PUBLIC INTEREST REVIEW FOR GROUNDWATER APPLICATIONS

SUBJECT: Application G- 18147 Supersedes review of _____
Date of Review(s)

A. GENERAL INFORMATION: Applicant's Name: Kenneth Burbank County: Deschutes

Well Location Maps

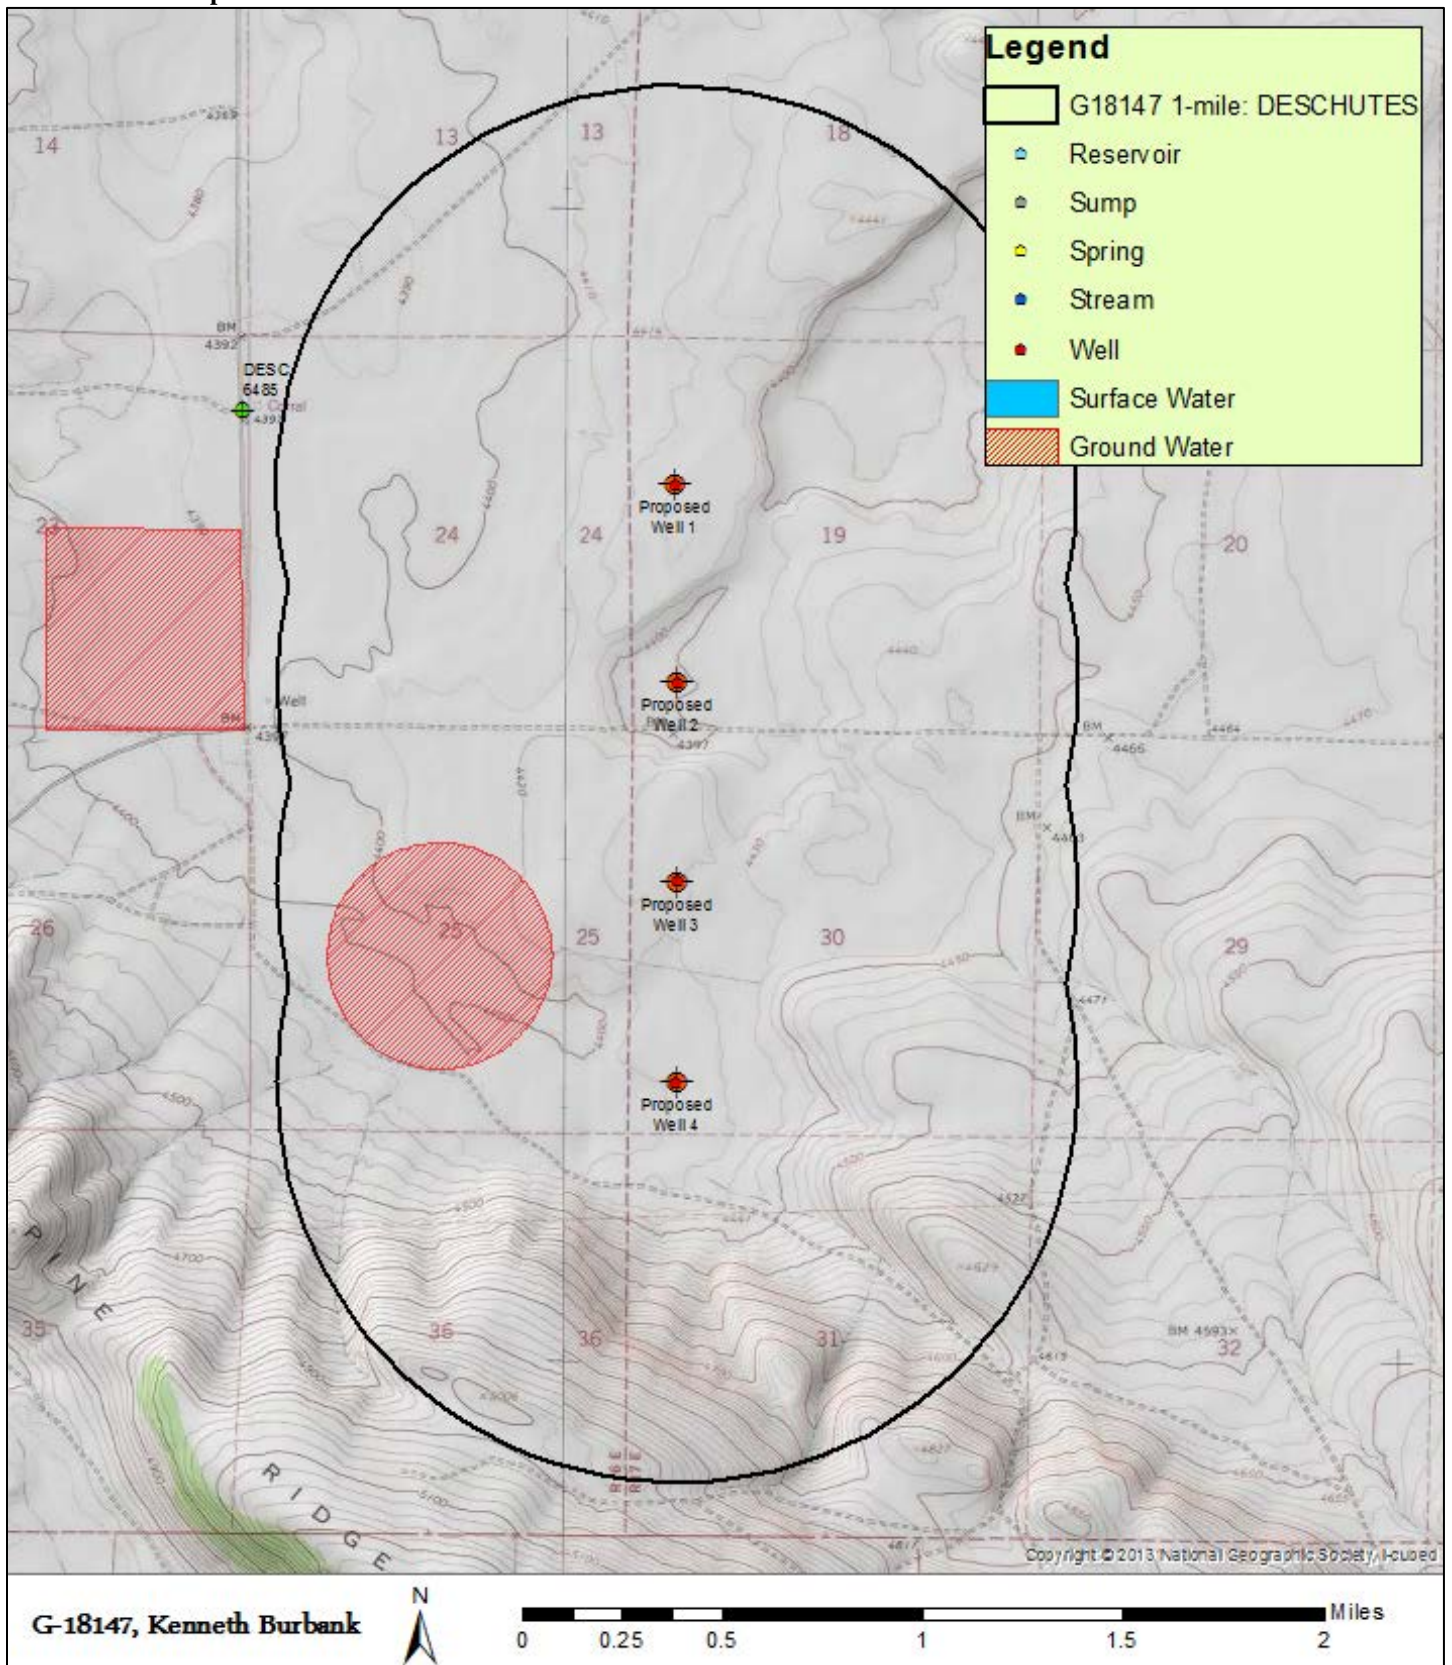
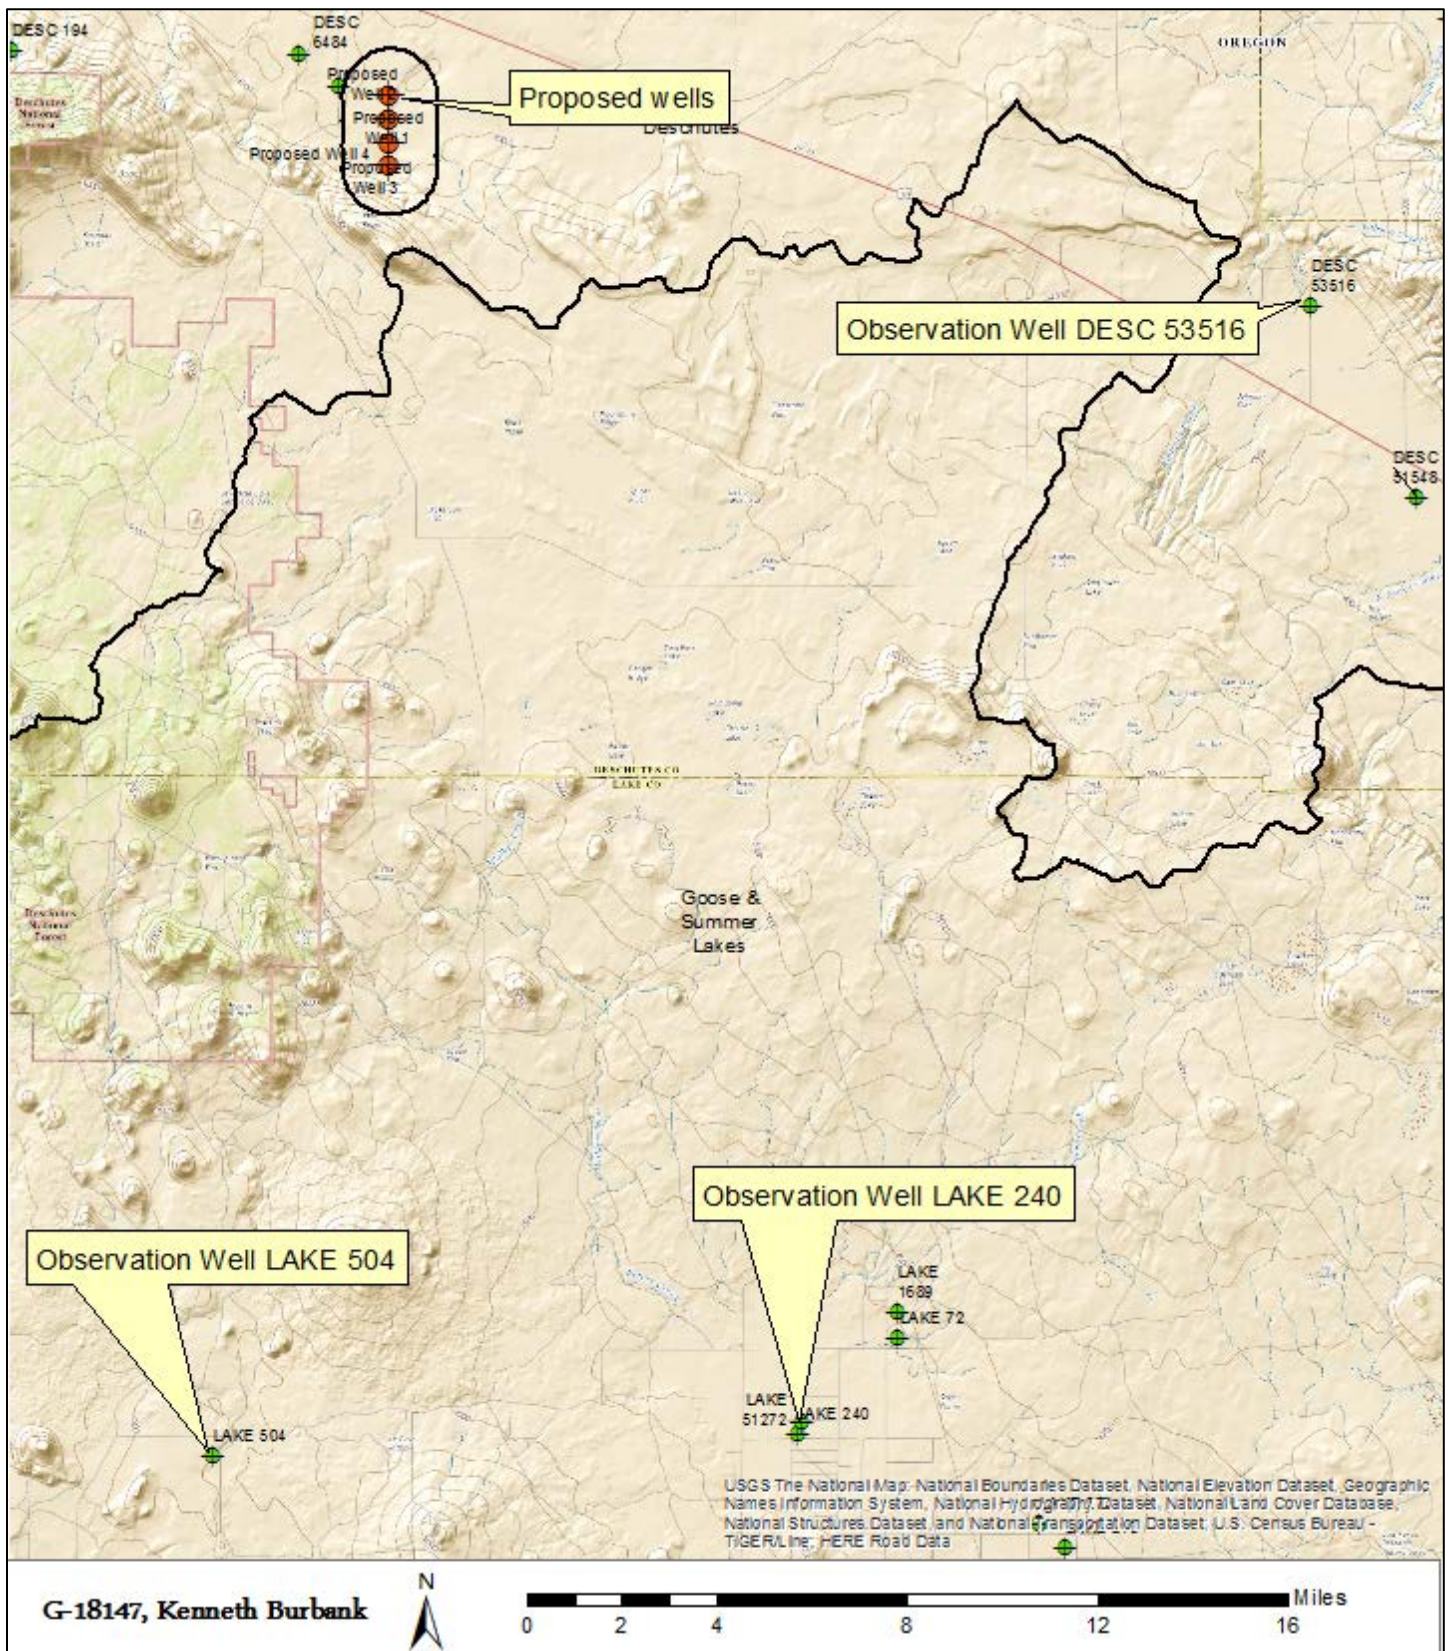
There are no nearby State Observation Wells. The nearest State Observation Well within the same basin with a likely similar response is DESC 53516, located about 20 miles to the east-southeast (see map below). It has been monitored periodically since 1993. Overall, DESC 53516 shows a downward trend throughout the period of record. This trend is consistent with climate cycles. Since 1993, the water level has dropped about 5.75 feet, likely, mostly as a result of decreased recharge. Two additional State Observation wells (LAKE 240, ~28 miles to the south-southeast and LAKE 504, ~28 miles to the south-southwest) located in the upper margin of the Goose & Summer Lakes Basin show a similar downward trend, likely also mostly as a result of decreased recharge (see hydrograph below), speaking to the effects of the climatic cycle in a larger region.
